Re: Request for Permit Modification to Add an AST and Commercialization to an Approved C-147 Containment and Recycle Facility (2RF-103) in Eddy County, New Mexico

TRIONYX CONTAINMENT AND RECYCLING FACILITY
DEVON ENERGY CORP.
EDDY COUNTY, NEW MEXICO

The NMOCD has reviewed the recycling containment permit modification and related documents, submitted by [6137] DEVON ENERGY PRODUCTION COMPANY, LP on 6/12/2025, Application ID **473484** for 2RF-103 - TRIONYX CONTAINMENT AND RECYCLING FACILITY ID [fAB1526137120].

AST LEAK DETECTION SYSTEM DETAIL
NOT TO SCALE

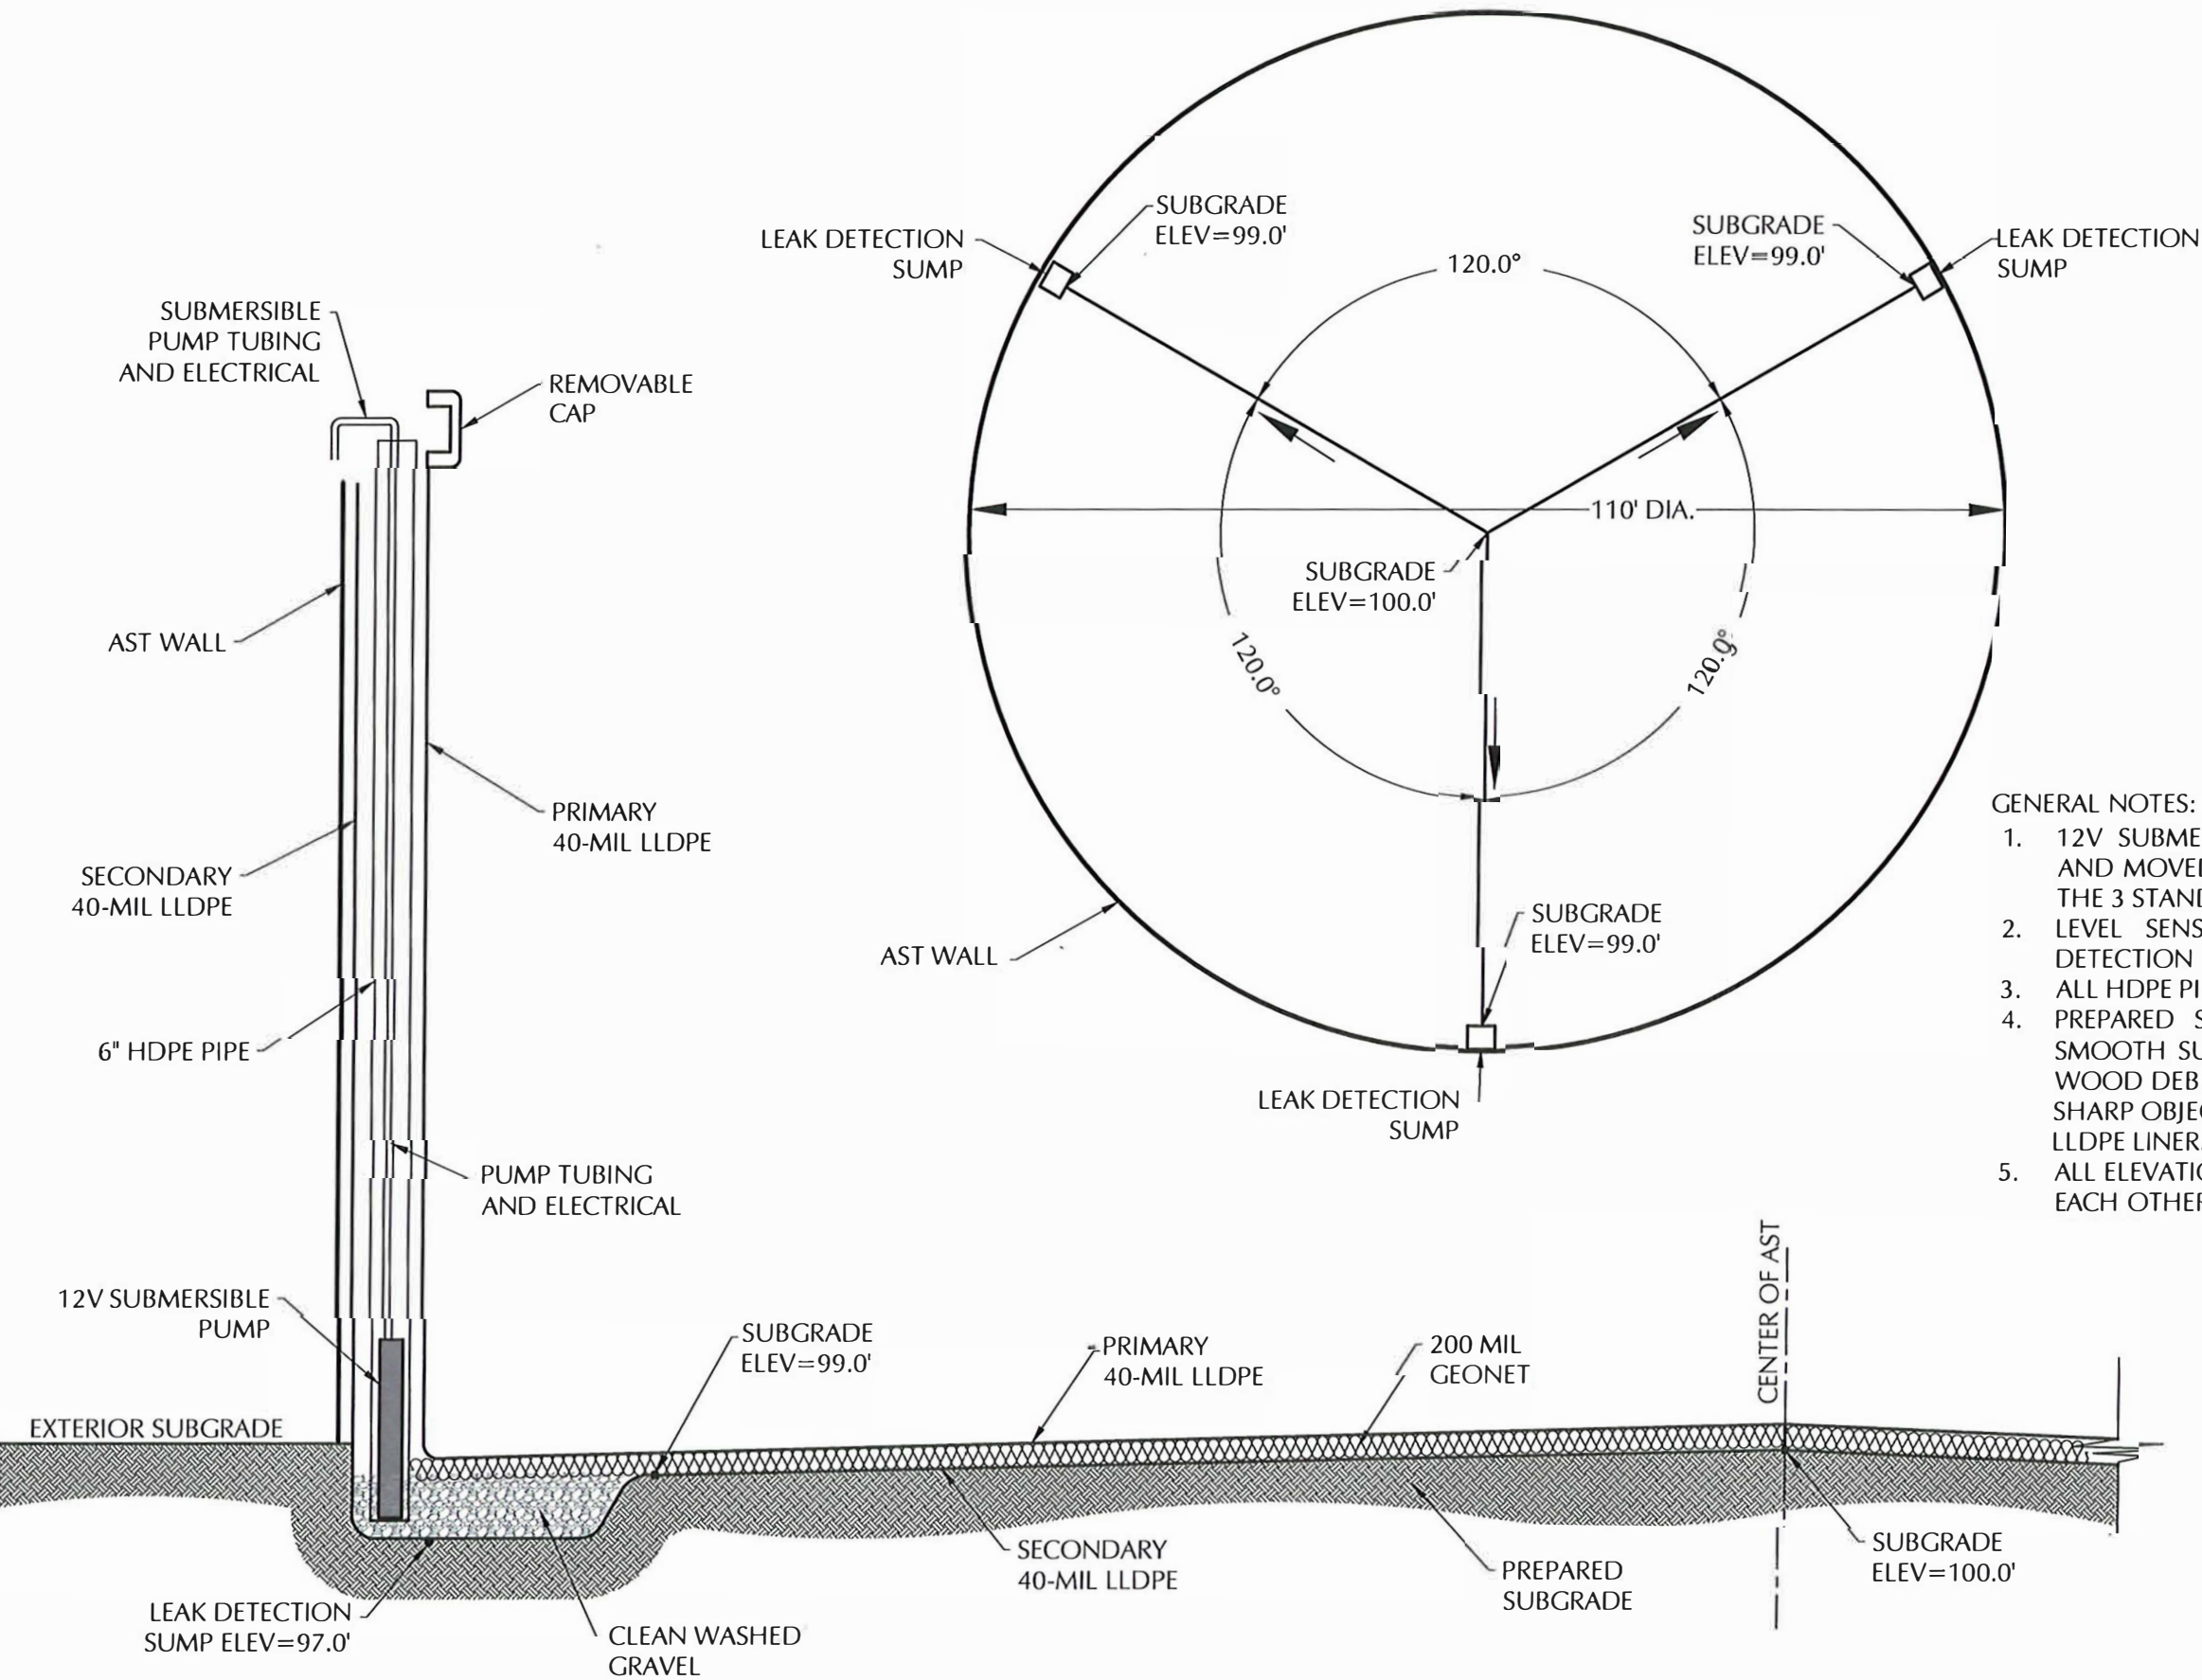
If seepage from the containment into the leak detection system is suspected by a positive fluid level measurement, the operator will:

1. Re-measure fluid levels in the monitoring riser pipe on a daily basis for one week to determine the rate of seepage.
2. Collect a water sample from the monitoring riser pipe to confirm the seepage is treated produced water from the containment via field conductivity and chloride measurements.

3. Notify NMOCD of a confirmed positive detection in the system within 48 hours of sampling (initial notification).
4. Install a pump into the monitoring riser pipe sump to continually (manually on a daily basis or via automatic timers) remove fluids from the leak detection system into the containment until the liner is repaired or replaced.
5. Dispatch a liner professional to inspect the portion of the containment suspected of leakage during a "low water" monitoring event.
6. Provide NMOCD a second report describing the inspection and/or repair within 20 days of the initial notification.
